Serial No. : 10/771,812
Filed : February 4, 2004

REMARKS

FIG.1

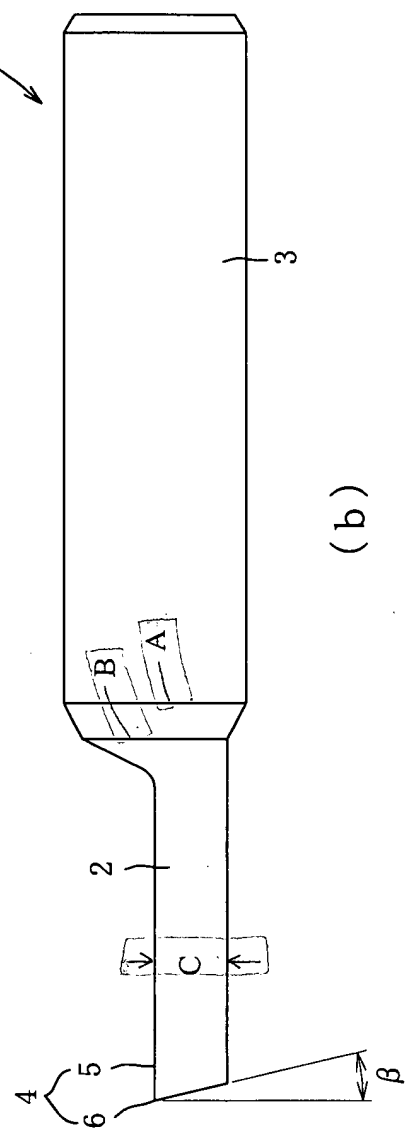
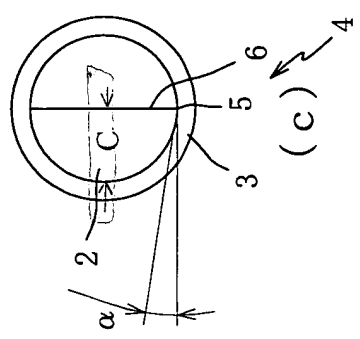
The limitation of "the semi-cylindrical body portion has a half-moon shape in cross section" is supported by the bottom view of Fig. 1(c) which shows a straight line (end cutting edge portion

6) running the center of the circle (tapered end of the cylindrical shank portion 3). The limitation of "the cutting tool cuts the workpiece while being kept unrotated" is supported by the description in the specification, for example, in the paragraphs [0032] and [0038] and the drawing, for example, Fig. 7, which clearly show that the cutting tool 1 cuts the workpiece without rotation. The limitation of "the rake angle of the rake face is 0° when cutting the workpiece" is supported by the specification at the paragraphs [0032] and [0038] each of which indicates that the rake face 8 is always held perpendicular to the predetermined direction (moving direction), because, by definition, the rake angle is zero when the rake face is perpendicular to the moving direction, i.e., the rake face is parallel with a tool reference plane throughout the operation.

The applicant has submitted concurrently herewith a request for approval of drawing changes in which reference characters are added to Figs. 1(b) and 1(c) to more clearly describe the shape of the cutting tool.
